# Access Compliance Report

## Public Rights-of-Way

### (Curb Ramps)

Intersection ID: N/A	Main Street: CONFERENCE_DR	Cross Street: OLD_POST_RD	Location: SW
ADA ID: D87A1A3BC290	Ramp Type: Directional1	Initial Pass/Fail: Fail	Overall Compliance: No
Codes/Mitigation Info/Possible Solution		Field Measurements/Component Compliance

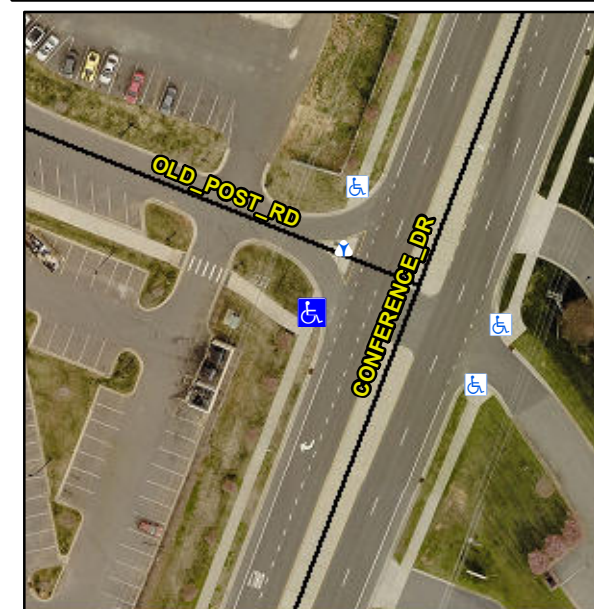
**R304.5.3**

Compliance	Description	Data	Compliance	Description	Data
N/A	Ramp Length (in)	98.0	N/A	Grade Break?	N/A
Yes	Ramp Width (in)	75.0	N/A	Grade Break Slope (%)	0.0
Yes	Ramp Slope (%)	7.3	N/A	Grade Break XSlope (%)	0.0
No	Ramp XSlope (%)	3.6			
N/A	Flare Type LT	N/A	N/A	Flare Type RT	N/A
N/A	Flare Slope LT (%)	N/A	N/A	Flare Slope RT (%)	0.0
N/A	Flare Traversable LT?	N/A	N/A	Flare Traversable RT?	N/A
N/A	Landing Length (in)	0.0	N/A	DWS Provided?	N/A
N/A	Landing Width (in)	0.0	N/A	DWS Contrast?	N/A
N/A	Landing Slope (%)	0.0	N/A	DWS Length (in)	N/A
N/A	Landing X Slope (%)	0.0	N/A	DWS Full Width?	N/A
N/A	Landing Curb? (Y/N)	N/A	N/A	DWS Offset LT (in)	N/A
N/A	Shared Landing?	N/A	N/A	DWS Offset RT (in)	N/A
N/A	Gutter Ponding?	0.0	N/A	Gutter Slope (%)	N/A
N/A	Gutter Lip Ht (in)	0.0	N/A	Gutter X Slope (%)	N/A
N/A	Painted X Walk1?	No		Road Slope (%)	1.8
	X Walk 1 Direction	To NE		Road X Slope (%)	3.0
	X Walk 1 Width (in)	N/A		Clear Space?	N/A

**Remove & Replace Entire Ramp.**
